This Value Engineering report summarizes the results of the Value Engineering study performed by Ventry Engineering for the Kentucky Transportation Cabinet. The study was performed during the week of February 2-6, 1998.

The subject of the study was the I-75 Widening from KY 36 to KY 491 (Williamstown to Crittenden).

I-75
 STA. 15+100 TO STA. 15+500

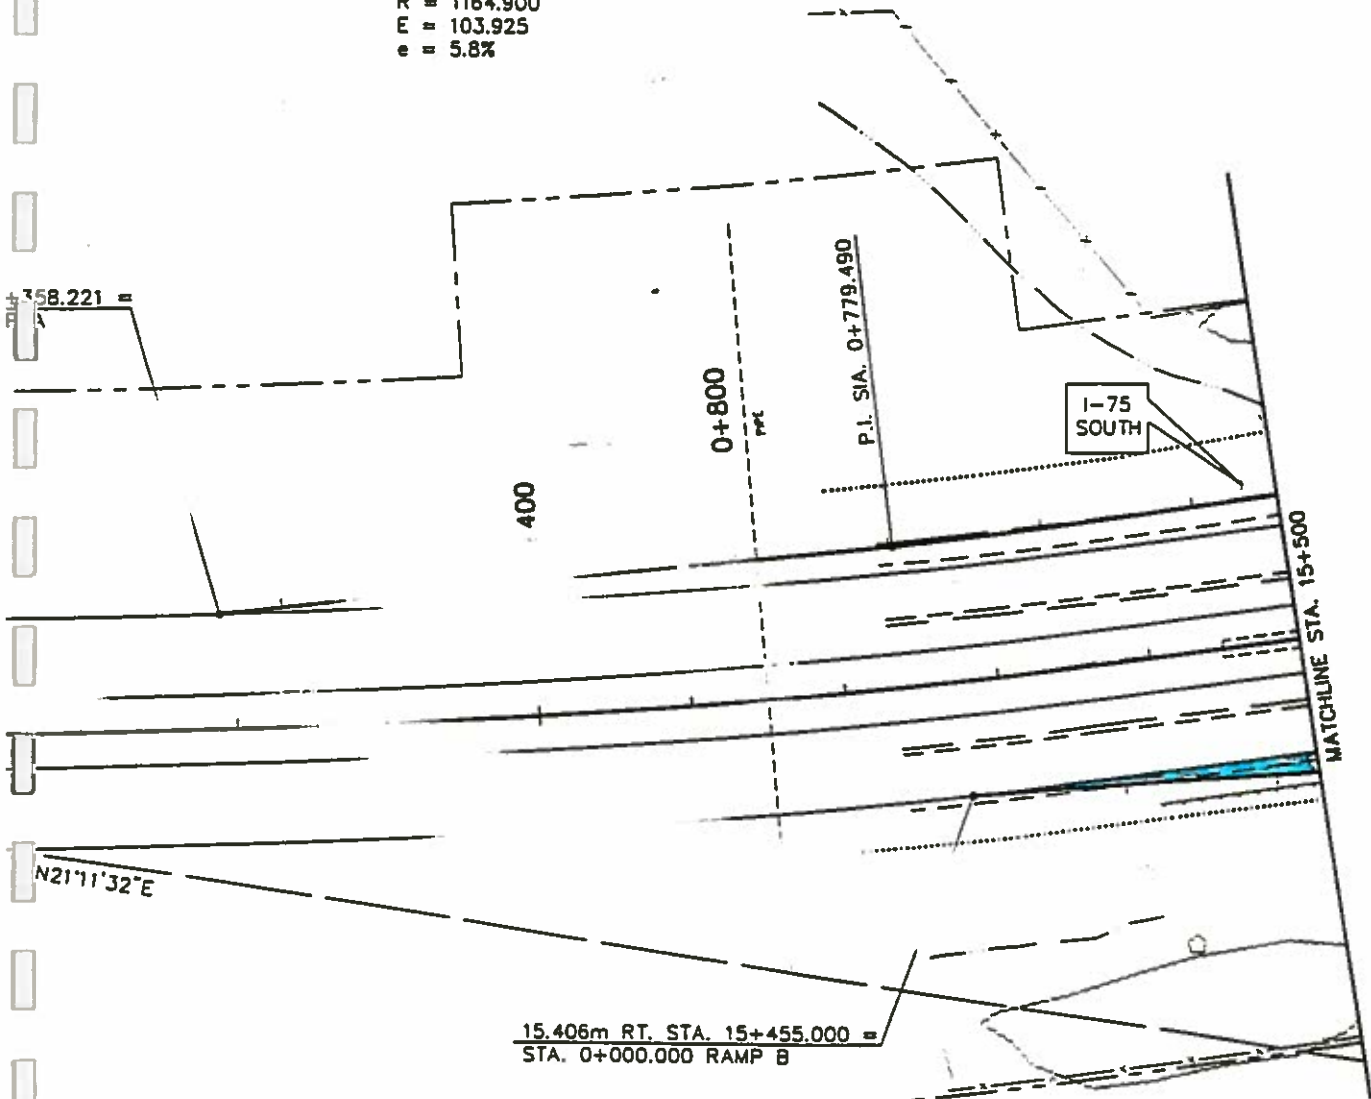
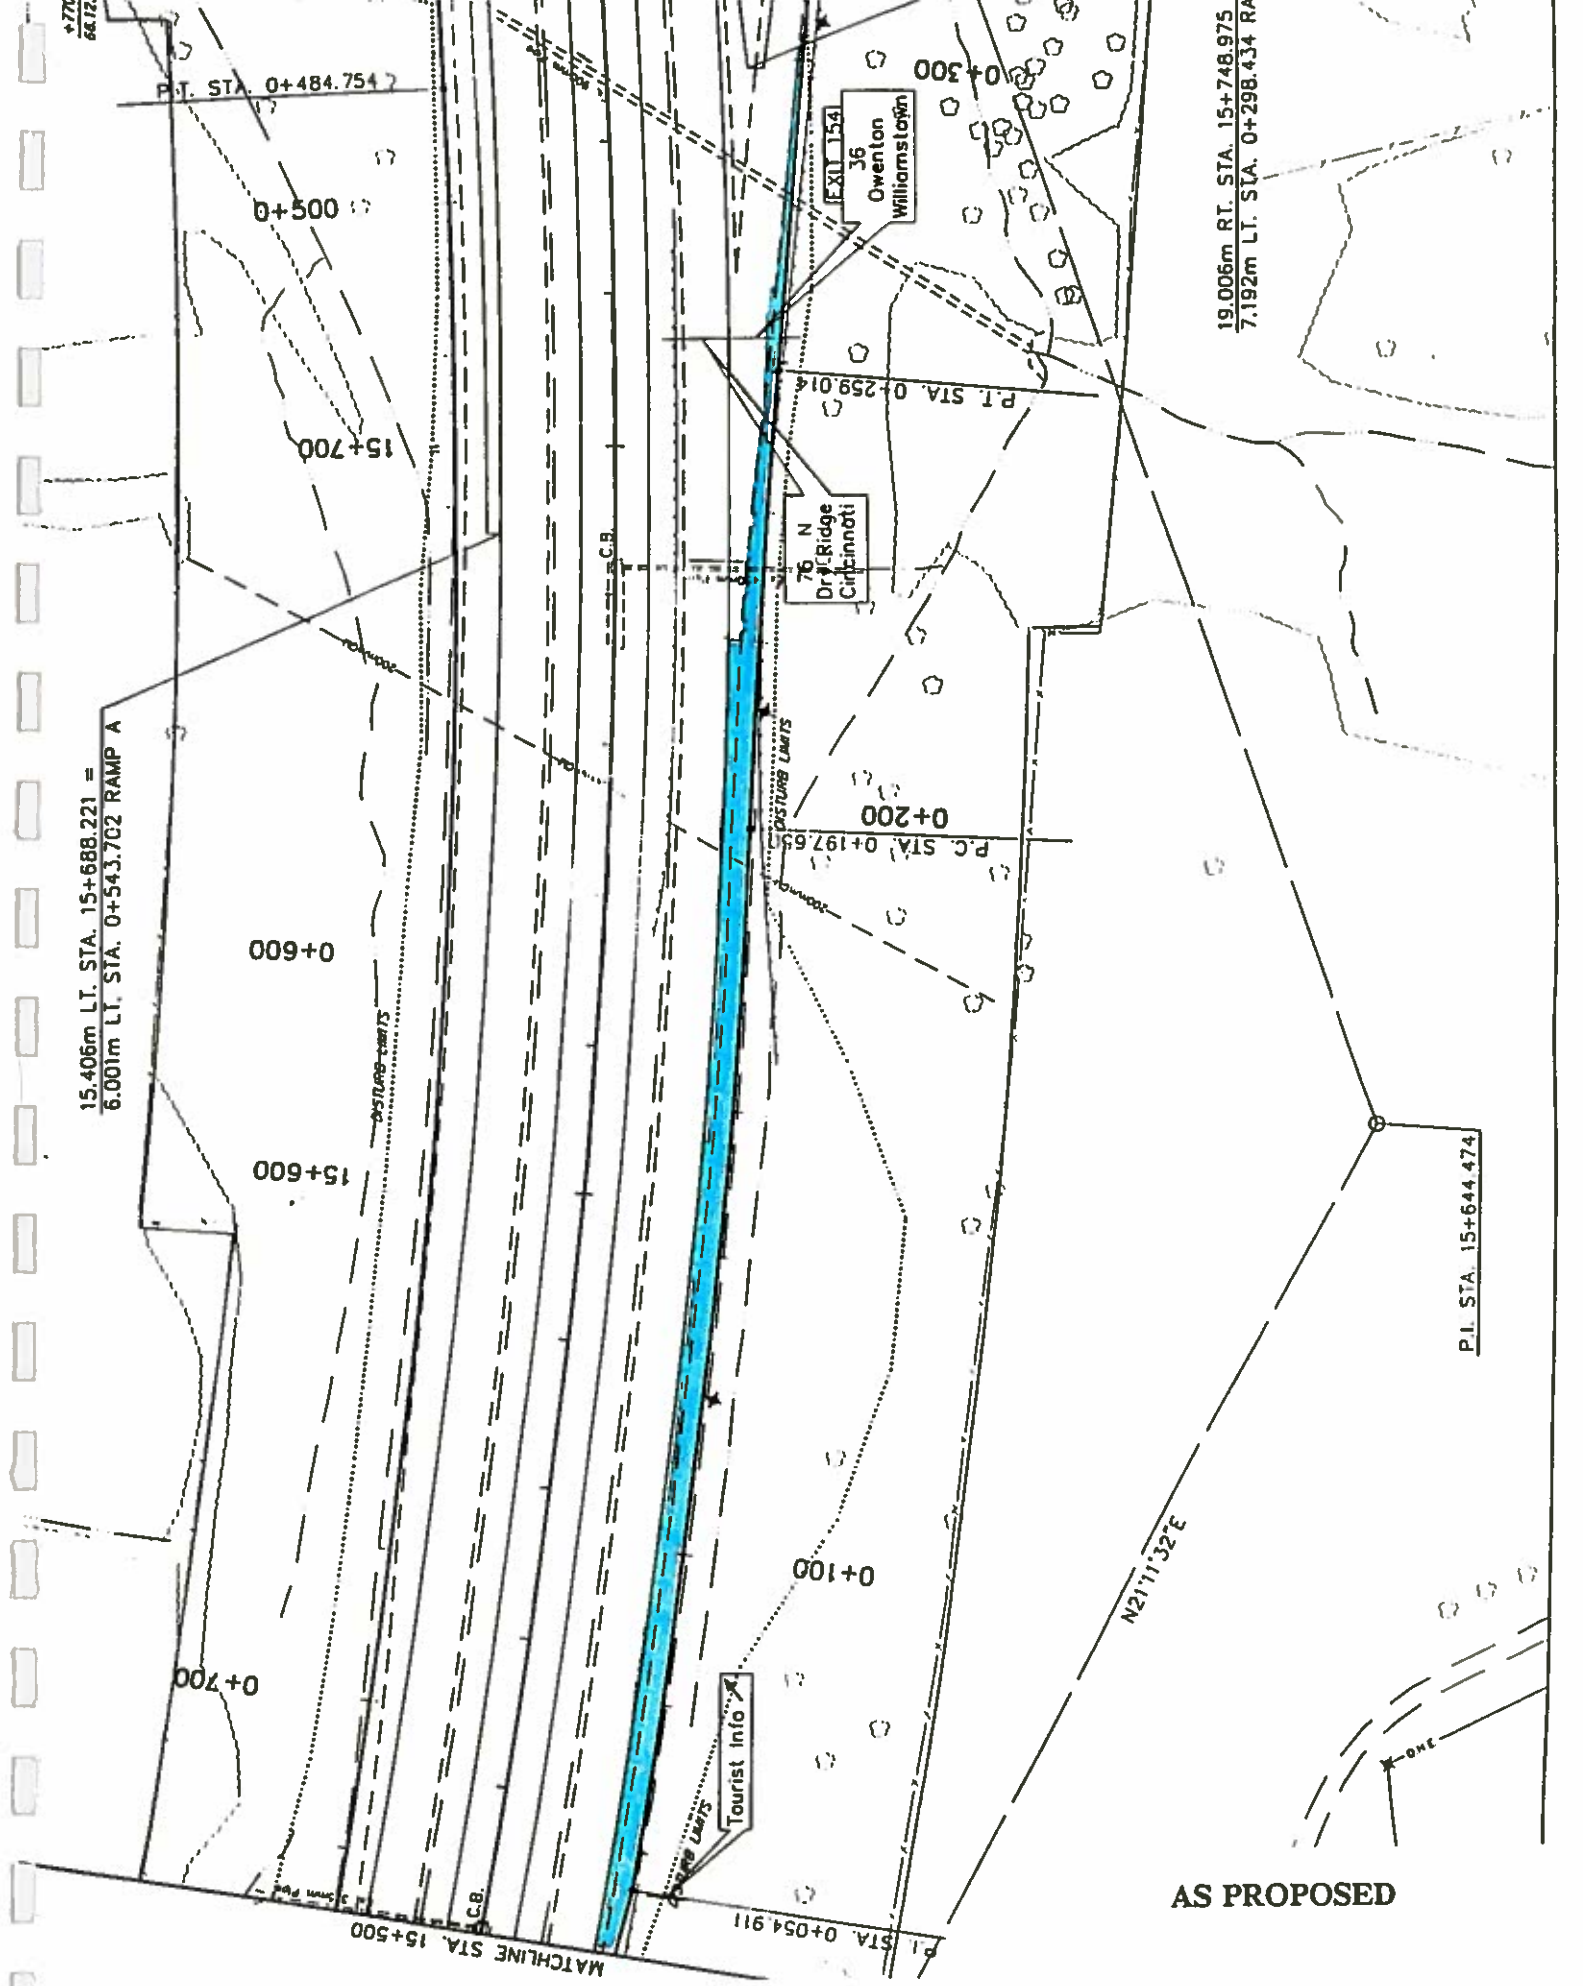
The "As Proposed" solution to this problem is to add a parallel exit lane preceded by a 25:1 exit taper. It is the teams opinion that this could make the problem worse by making it easier for a through vehicle to get into the exit lane by mistake.

- **Place thermoplastic rumble strips (standard spacing) on the exit ramp**
- **Paint the ramp gore Chevrons**
- **Paint the outside edge of the outside mainline lane with a dashed edge stripe through the ramp exit area**
- **Add a flashing beacon to the "stop ahead" warning sign**

TYPICAL SECTIONS

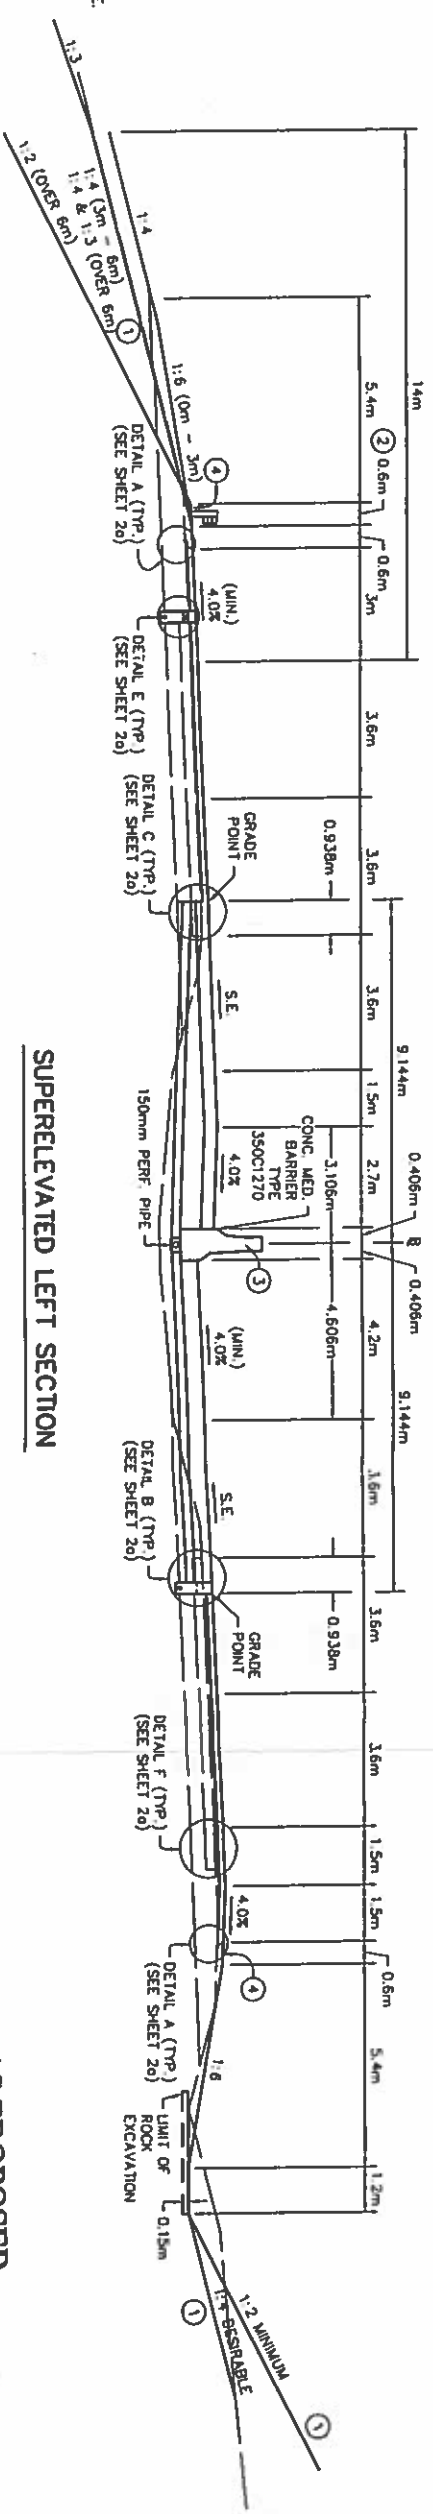
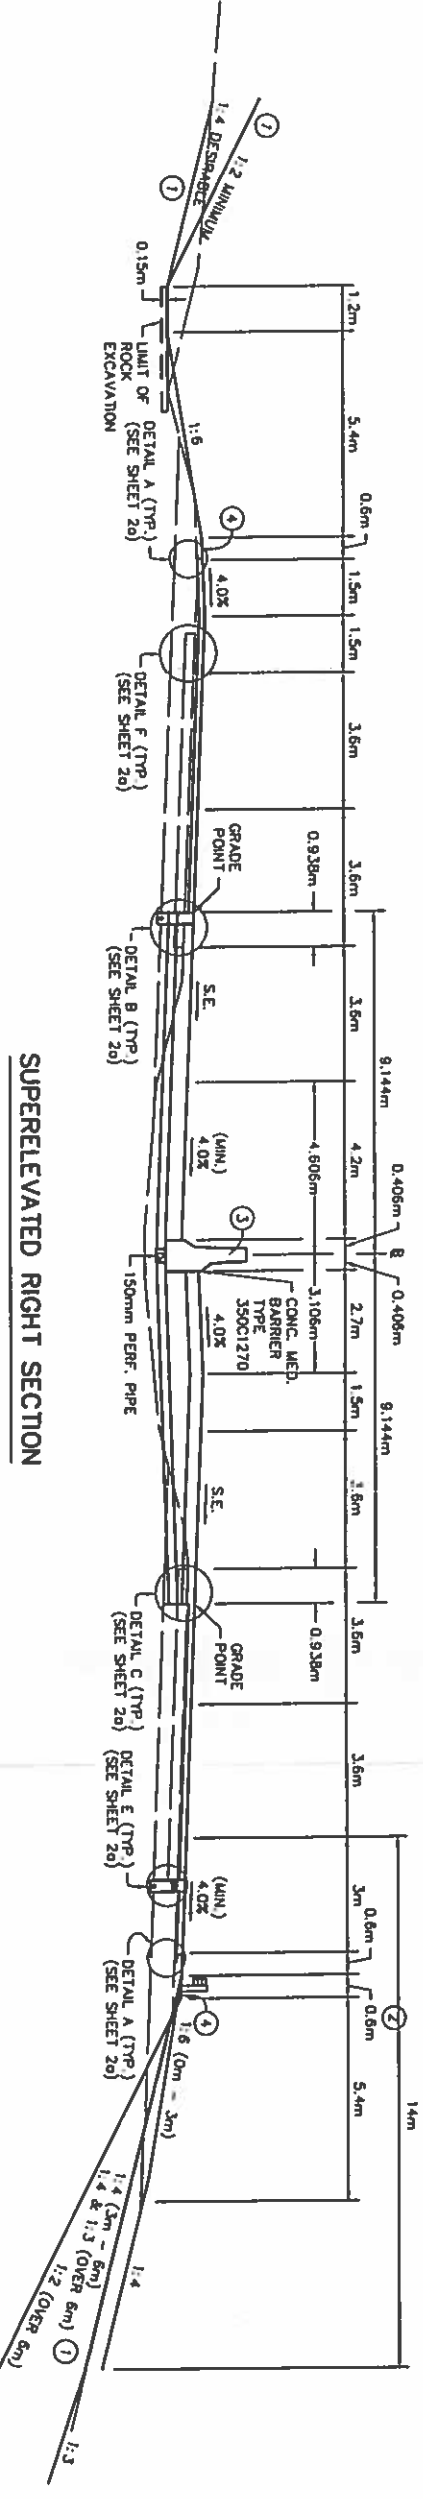
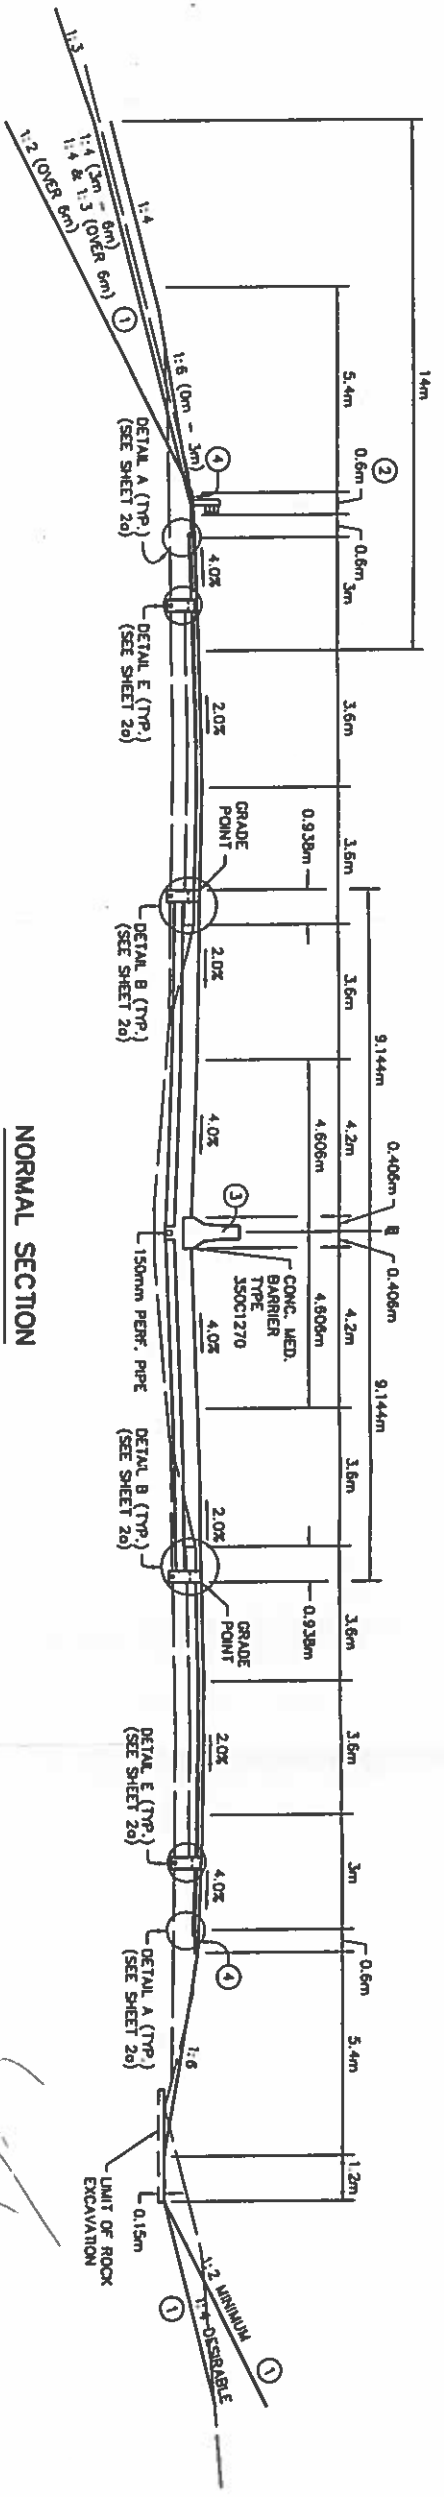
The proposed typical section calls for a median shoulder width of 4.2m (14ft) in the portion of the project, (15,442m) that has an existing constant width median of 60 ft. (18.29m). In those areas where guardrail is required on the outside edge of the roadway, the proposed plans include widening the roadway section 0.6m (2 ft.) on the outside to provide adequate width for the installation of the guardrail.

In reviewing the proposed median shoulder widths, the Value Engineering team agreed that the 3.0m (10 ft.) paved median shoulder in the variable width median section of the project is the appropriate design. In this section of the project it is assumed that the independent horizontal alignments of the two roadways will be adjusted as necessary to provide adequate width on the outside edge of the roadway sections for the installation of guardrail. This will permit all grading for the pavement widening to be accomplished in the median area and the retention of the existing outside cut and fill slopes, with the exception of those areas where outside slope improvements may be warranted.

By reducing the median shoulder width to 3.6m (12ft.) as shown in the typical section, the overall directional roadway width from the centerline to the hinge point is reduced to 19.006m at guardrail locations and to 18.406m at other locations. With the existing graded roadway width of 20.12m as shown on the plans, there is an excess of approximately 0.5m to 1.0m of graded area which reduces the degree to which the existing established outside fill and cut slopes need to be disturbed to provide minor slope flattening between the hinge point and the ditch line.
